UNITED STATES PATENT AND TRADEMARK OFFICE

APPLICATION NO.	FILING DATE	FIRST NAMED INVENTOR	ATTORNEY DOCKET NO.	CONFIRMATION NO.
10/572,775	06/29/2006	Bogdan Vuletic	P/3240-110	9439
2352 7590 12/24/2008 OSTROLENK FABER GERB & SOFFEN 1180 AVENUE OF THE AMERICAS NEW YORK, NY 100368403				
EXAMINER LAZORCIC, JASON L				
ART UNIT 1791		PAPER NUMBER		
MAIL DATE 12/24/2008		DELIVERY MODE PAPER

Office Action Summary**Application No.**

DETAILED ACTION

【図2】

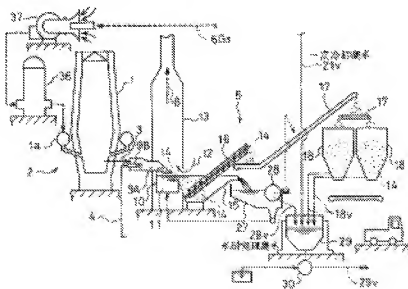
11. Regarding independent **Claim 1** and with particular respect Kiyoshi figures 1, 2, and 3 (see particularly excerpt figures 1 and 2 below), Kiyoshi teaches a process for granulating slag from a blast furnace (2).

The reference specifically teaches feeding a granule/water mixture formed during granulation (9A, 9B) to a granulation tank (1) then to a dewatering installation (5) to dewater the slag granules.

H₂S-containing vapors and gases (6G) formed during the granulation are at least partially condensed by water injected at a water injection point (21b) in the condensation space (13) which is flow connected to the granulation tank (10). Residual H₂S gases are discharged from the condensation space (13) below the water injection point (22a). The discharged gases (6G₃) are directed in "countercurrent" or recycled back to the slag blast furnace (2) wherein the gases are burned (¶[0070]) during formation of hot slag or "through a hot slag channel".

【圖 1】

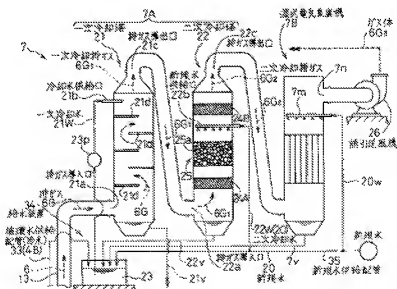
Regarding **Claim 2**, the blast furnace (2) which is capable of supporting gaseous combustion process therein is construed to read upon the claimed combustion chamber.

Regarding **Claim 10**, Kiyoshi teaches that condensate formed in the condensation space and water injected to the condensation space is discharged (21v) and fed to the water which has been separated off in the dewatering installation (29). Said water (29) is recirculated for granulation (4) and water injection (31).

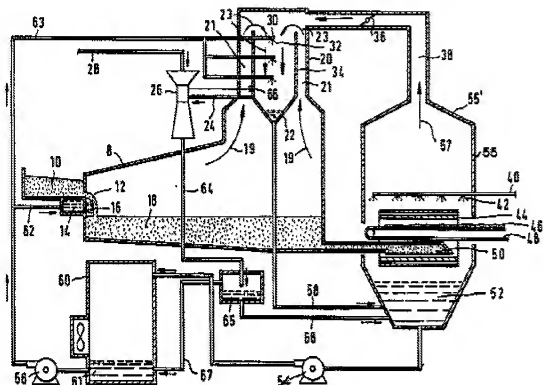
The United States patent to Faber (US 5,540,895) teaches a method for granulating slag with recovery of sulfur contaminated vapors. Specifically Faber teaches

feeding a granulated slag mixture to a granulation tank followed downstream by a dewatering apparatus. In the disclosed process, contaminated steam (19) generated during the granulation is at least partially condensed by injection of water from nozzles (30) in a condensation space. The reference further teaches that uncondensed gases are discharged below the water injection point (60) and recycled through the liquid scrubber system.

With respect to Claim 5, Faber teaches that the condensation tower (20) is closed at its lower end and separated from the dehydration or "dewatering installation" by a water barrier (Col. 4, lines 64-67). Faber teaches that such an arrangement "prevents the gases that are formed during the granulation process from being entrained towards the dehydration plant.

Similarly regarding Claim 7, Faber provides for a return conduit (38) from the dewatering installation back to the condensation tower (20) at a point above the water injection point for purification in the same manner as the contaminated steam originating from the granulation tank (Col. 6, lines 41-56). Such a vapor recovery insures more complete recovery of harmful H₂S and SO₂ gases from the granulation and dewatering facilities.
